Derby Diocesan Association of Church Bellringers Consultant's Report	Report no. DDACB 02/003
Inspection of Bell Installation at All Saints, Heath	Issue date: 4/03/003

FIGURE 1 BELL
FRAME LAYOUT
AT ALL SAINTS
HEATH

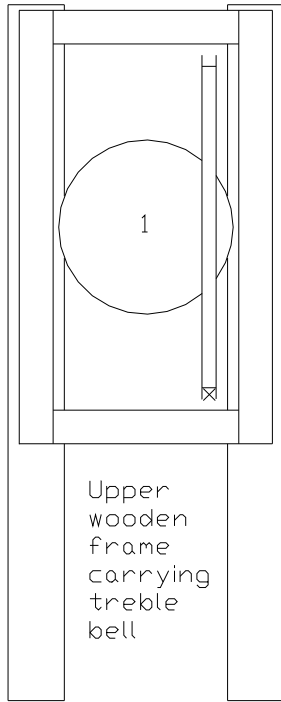
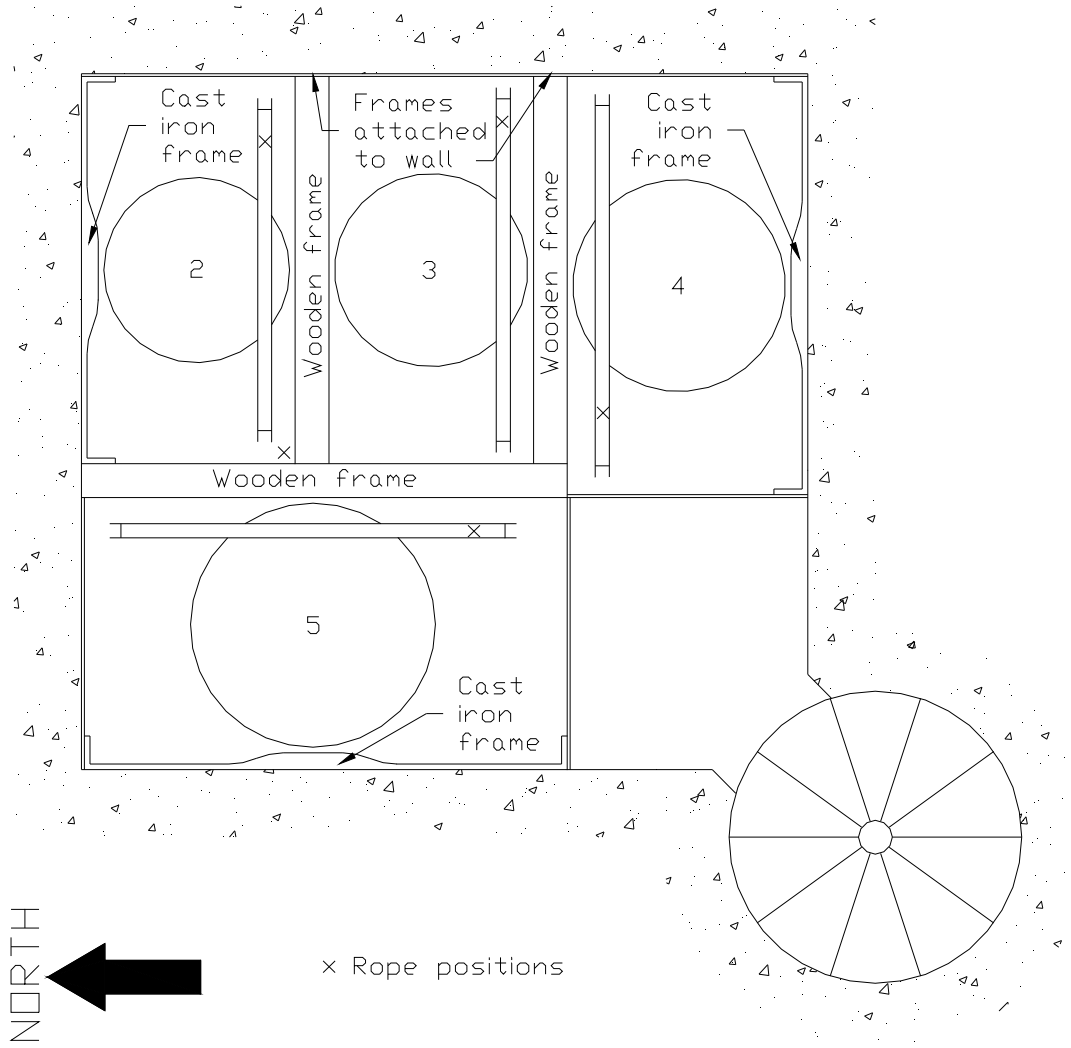
4.2 Frames (see figure 1)

Bells 2,3,4 and 5 are supported in a low sided composite frame sitting on foundation beams which are obscured by the bell chamber floor boards. This frame is largely constructed from wood and cast iron and is a tight fit in the tower. Bells 2,4 and 5 are supported by cast iron frame sections on their wall side and wooden frame sections on their inside. Wooden frame members support Bell 3 on both sides. Use of cast iron has provided more space to enable larger bells to be installed than would be possible with an all-wood construction.

Bell 1, the treble bell, is supported in its own wooden frame above bells 2 and 5.

Visually the frames appear to be structurally sound. There are no signs of rot in any of the wooden sections and the metal sections appear not to be compromised by rusting. To be more certain of the integrity of the frames, a dial gauge was used to measure frame movement whilst each bell was rung. (It is difficult to quantify movement by eye and use of sensitive measuring equipment is the only sure way to assess movement). Figure 2 shows the points at which measurements were taken, all being in the horizontal direction. In his quotation, Fred Pembleton casts doubt on the strength of the cast iron frames supporting bells 5 and 4 and so measurements at "A" and "B" address this concern. He also doubts the integrity of the upper frame foundation beam wall fixings and so measurements at "D" and "E" were taken to address this concern. In addition measurements were taken at station "C" since movement in the wooden frame set between bells 2 and 3 will impose an unwanted side load on the bearings of bell 5. The table below gives the results.

Direct attachment of the frame to the wall at point "C" contributes to the small movements observed here and removes any tendency for applying significant side loads to the tenor bearings. The section of wooden frame between bells 3 and 4 is attached in an identical manner. It is not good practice to stiffen a frame in this way but the job appears to have been done some time ago in a competent manner with no sign of subsequent distress to the adjacent stonework.

This generally good state of affairs can be preserved for future generations by:

- Check tightening of all screwed fittings including all tie bars in the wooden frames.
- Removing all rust from the metal frame sections and metal fittings with a wire brush and then painting with a coat of red oxide, a coat of primer and a top gloss coat of paint.
- Give the wooden frame sections a coat of Cuprinol wood preservative (or creosote)

FIGURE 2 FRAME MOVEMENT MEASURING STATIONS

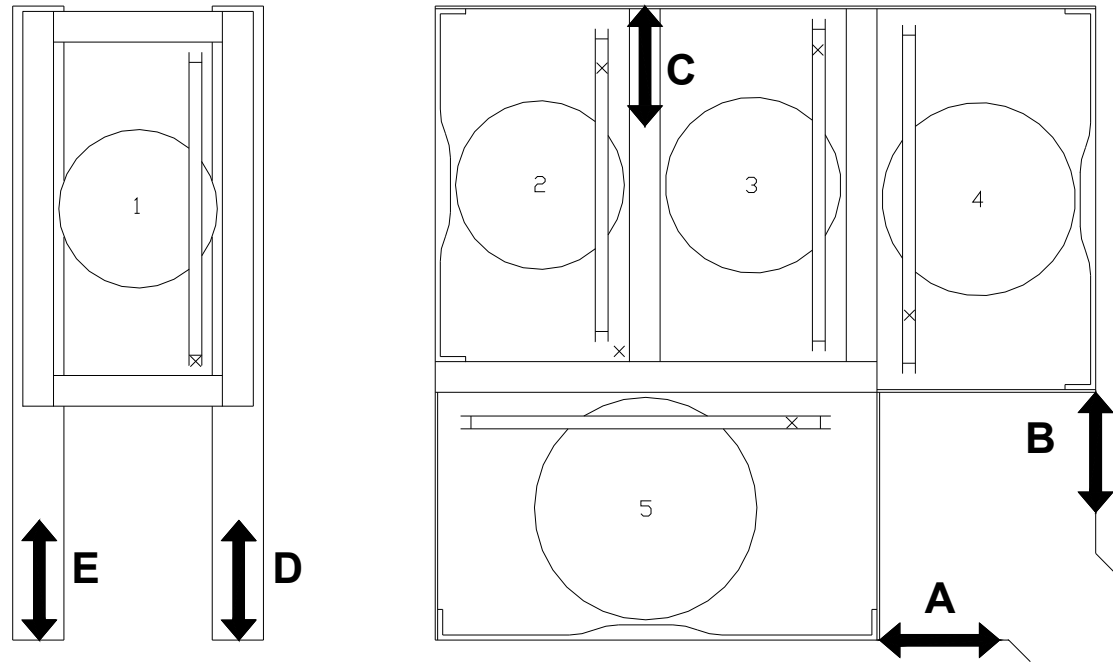
Bell Being Rung	Measuring Station	Movement (mm)
5	A	+/-0.3
4	B	+/-0.2
3	C	+/-0.15
2	C	+/-0.075
1	D	+/-0.02
1	E	+/-0.02

These results are commendably small and show the frames are very stable at the key points measured.
